# Kyoto II (EW5)

**BLOCK DIAGRAM**  
Date : Saturday, July 09, 2005 Sheet 1 of 30 Rev : 1A

1. change C201 470U/2.5V-7343,C205 220U/2.5V-3528 location and values
2. Change C541, C542 to 150p to fixed modem can't dial question
3. Change C533,C534 from 1U to 2.2U to fixed Audio measurement fail issued
4. ADD C570 10U to fixed system hard to power on, and change R252 to 1K
5. Remove R241, R243 , and Add R85
6. Add RP11 for internal LVDS
7. Change DDR2 connector to PI
8. Remove Q27, Q23, VGA PWRGD
9. Change battery charger and VCCP schematic.

# H/W MONITOR

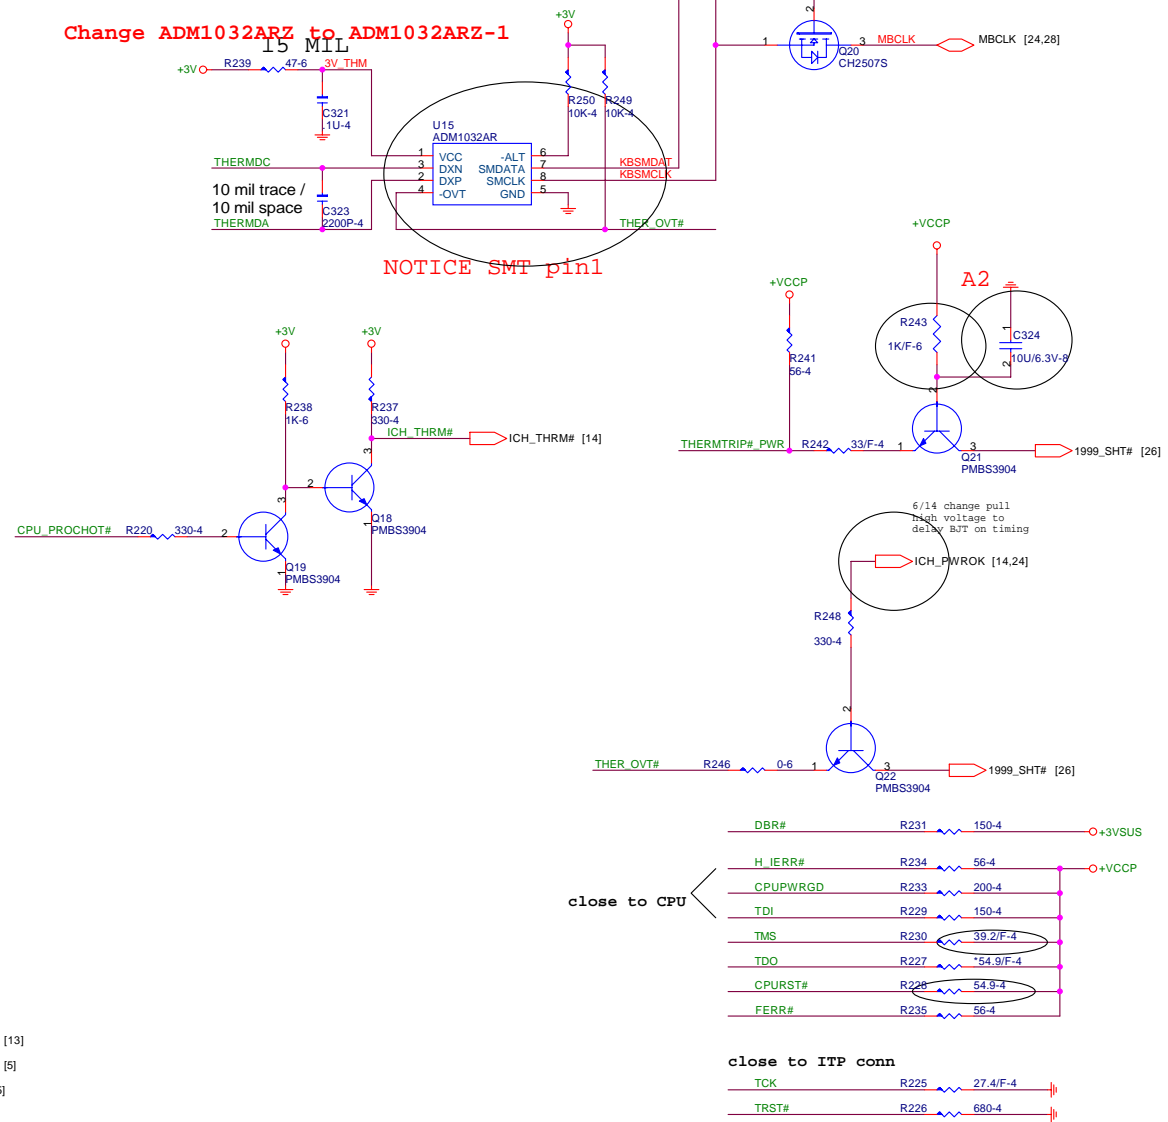
Change ADM1032ARZ to ADM1032ARZ-1

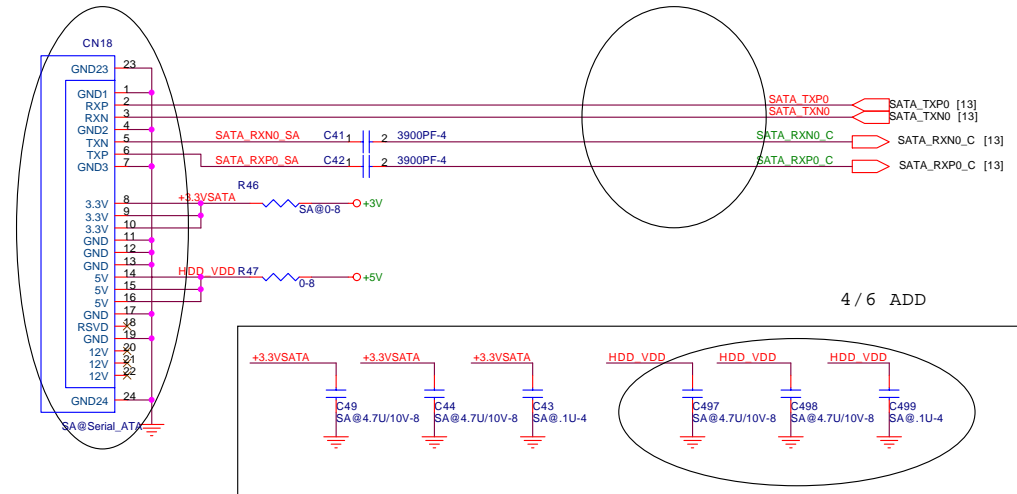
MakeSure Pin define 3/22 DEL STAT TO PATA bridge

4/8 DEL  
C276, C270

CARDBUS SLOT

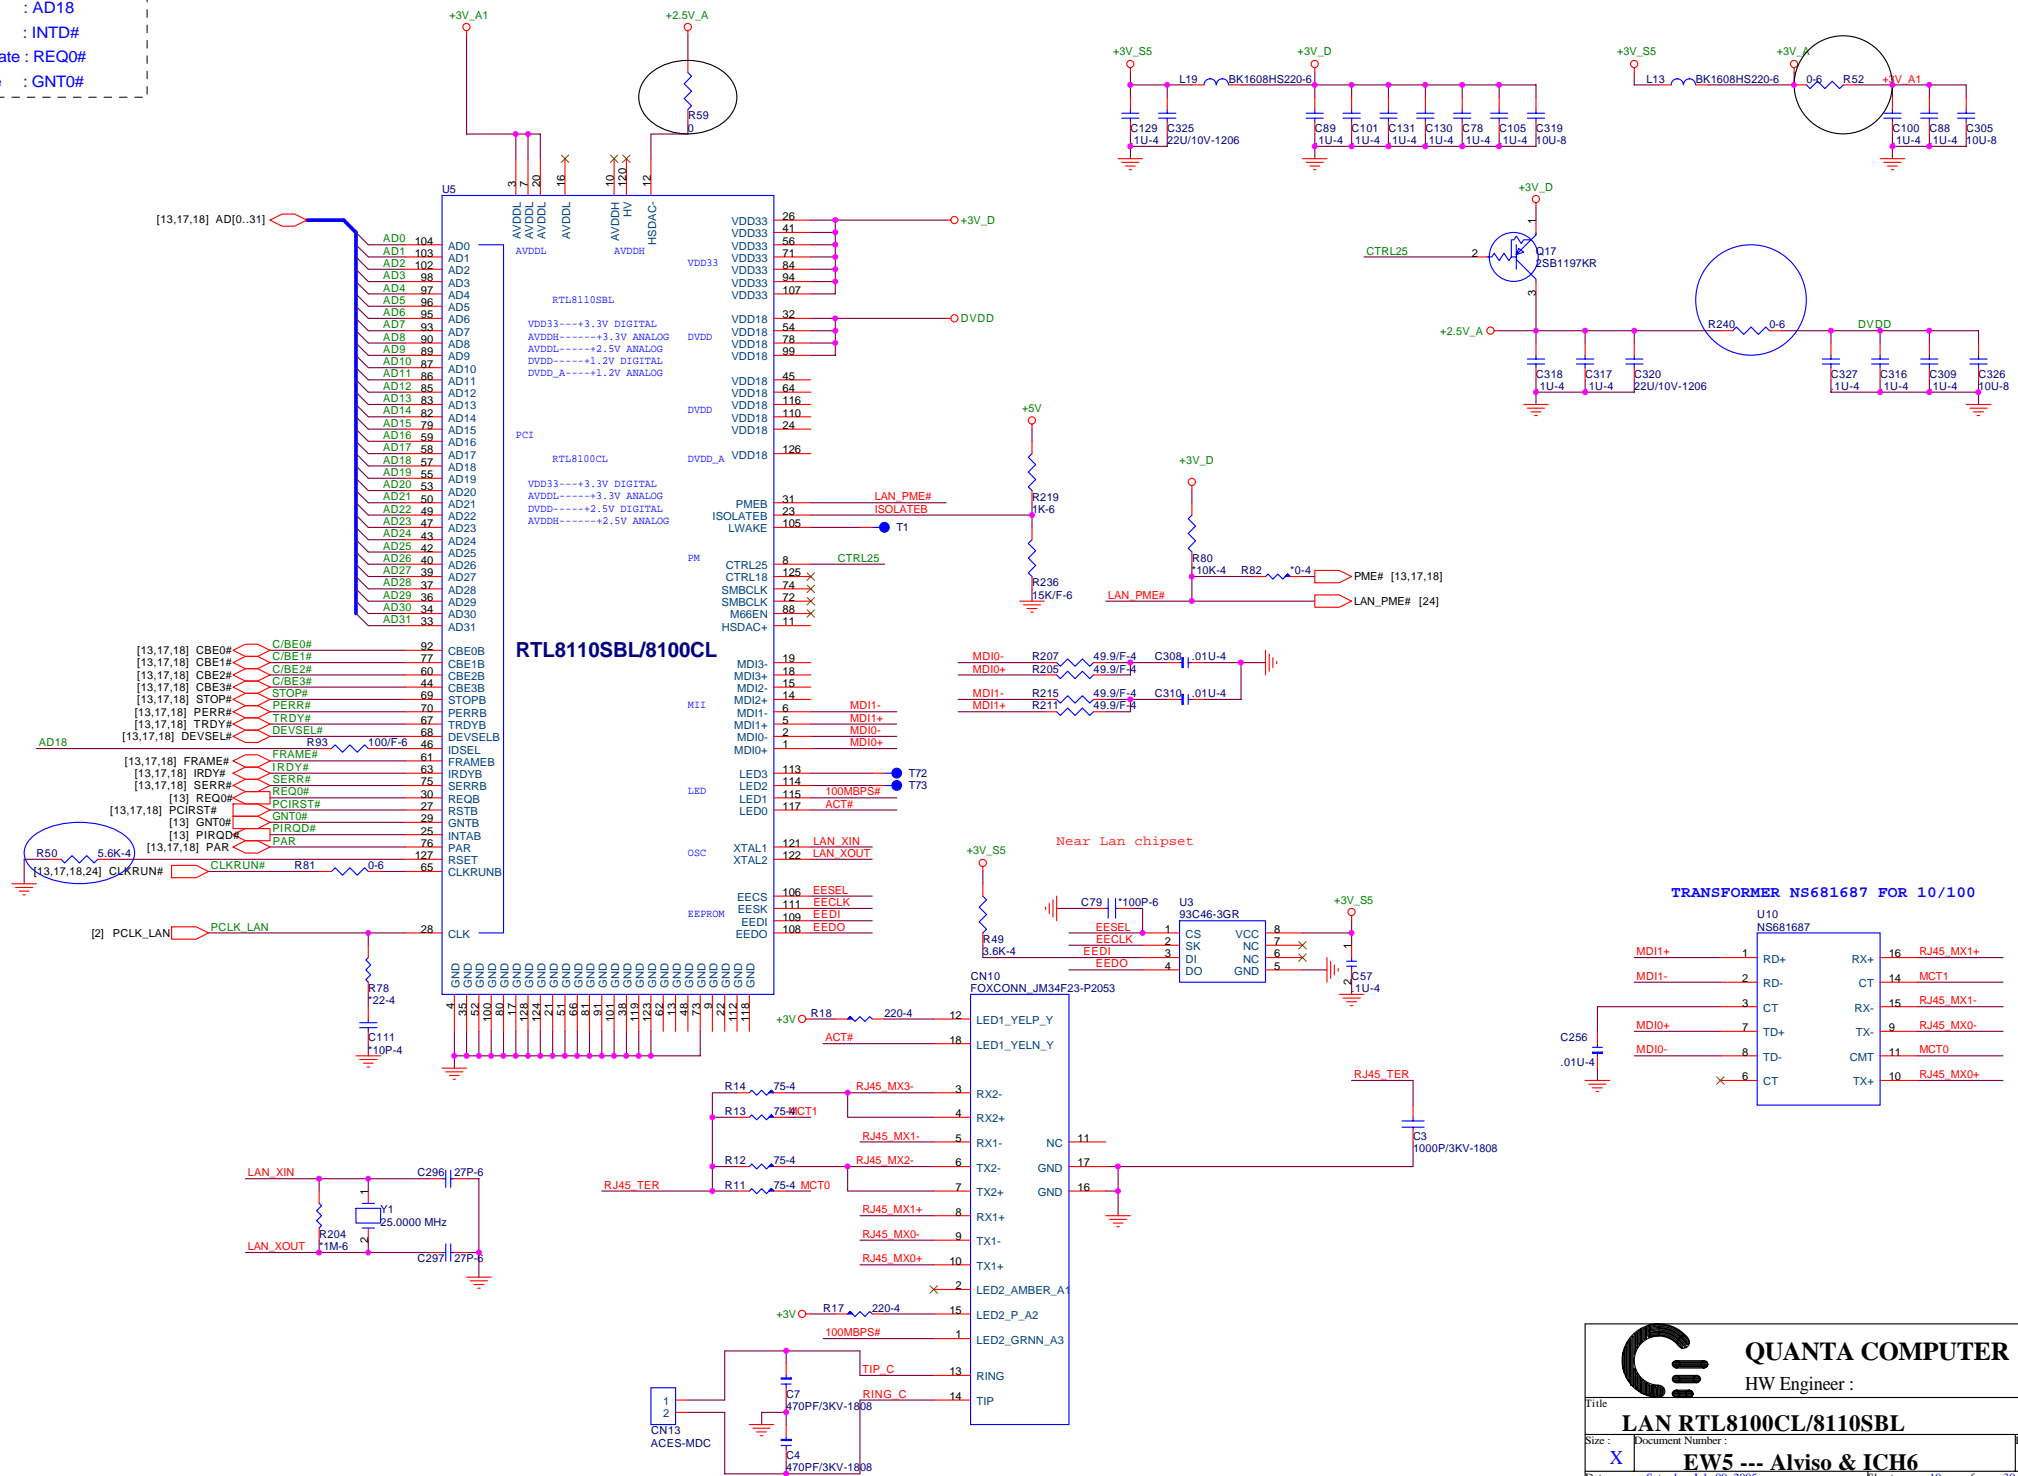
# 4/ 8 CHANGE PCB Footprint

HOLES

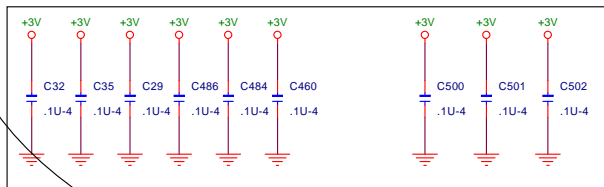
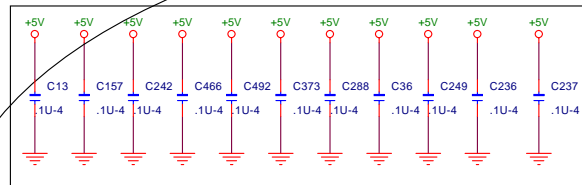
4/8 ALL EMI C ADD

3/15 EMI ADD

3/15 EMI ADD

4/6 ADD EMI 3 pcs

4/8 CHANGE TO 0603 SIZE 25V

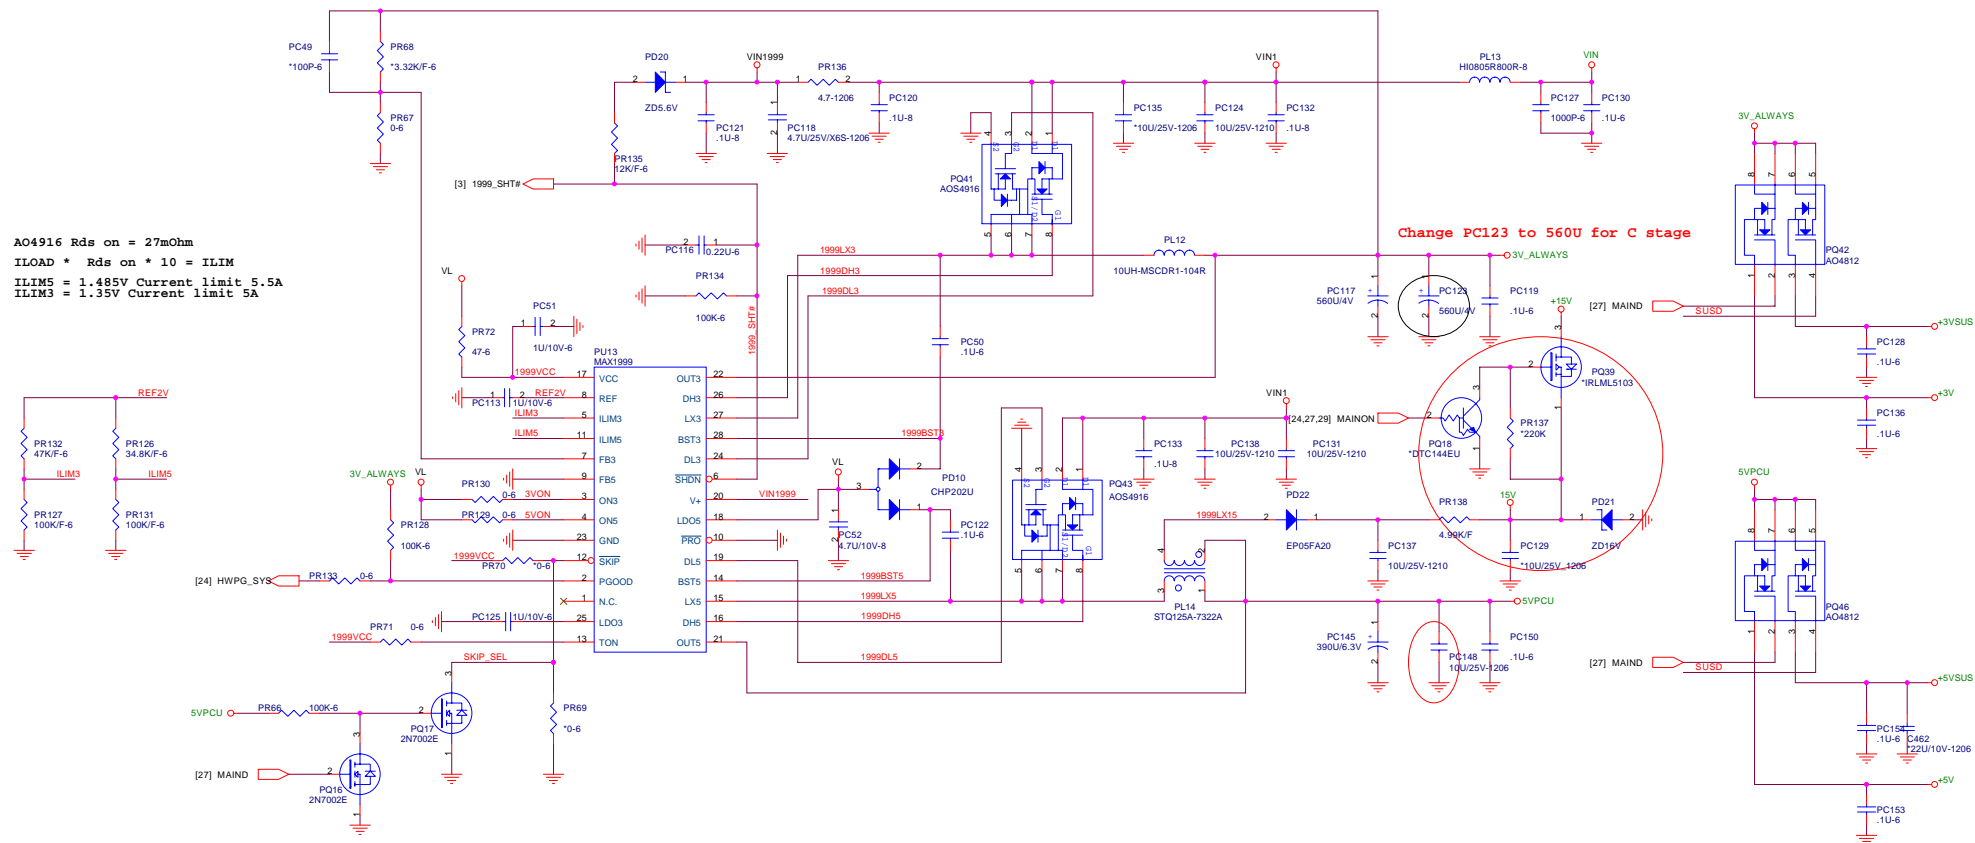
6/4 change ED1 connector
